STATE OF DELAWARE
EXECUTIVE DEPARTMENT
OFFICE OF MANAGEMENT AND BUDGET
STATE PLANNING COORDINATION

RE: PLUS review – PLUS 2007-01-01; Wood Property

Thank you for meeting with State agency planners on January 24, 2007 to discuss the proposed plans for the Wood property project to be located on the west side of Route 13, approximately 1 mile south of Felton.

According to the information received, you are seeking site plan approval for 239 residential units on 131 acres located partially in Level 3 and partially in Level 4 according to the *Strategies for State Policies and Spending*.

Wood Property (PLUS 2007-01-01) Excellent ground-water recharge potential area is highlighted in green. The parcel under review is outlined in light blue.

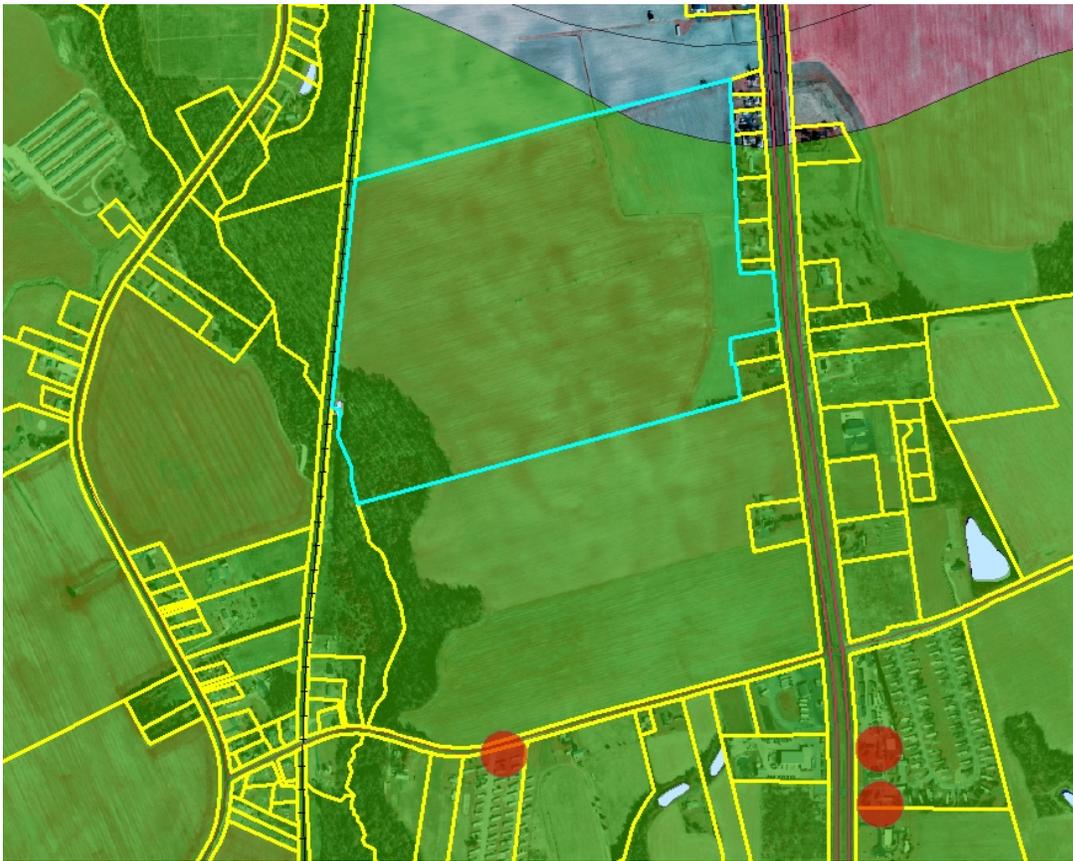
The DNREC Water Supply Section has reviewed the above referenced PLUS project and determined that it falls mostly within an excellent ground-water recharge area for the Kent County (see attached map). The site plan shows storm water management ponds in the area of excellent recharge.

The DNREC Water Supply Section recommends that the portion of the new development within the excellent ground-water recharge area not exceed 20% impervious cover (DNREC, 2005). The purpose of an impervious cover threshold is to minimize loss of recharge (and associated increases in storm water) and protect the quality and quantity of ground water and surface water supplies.
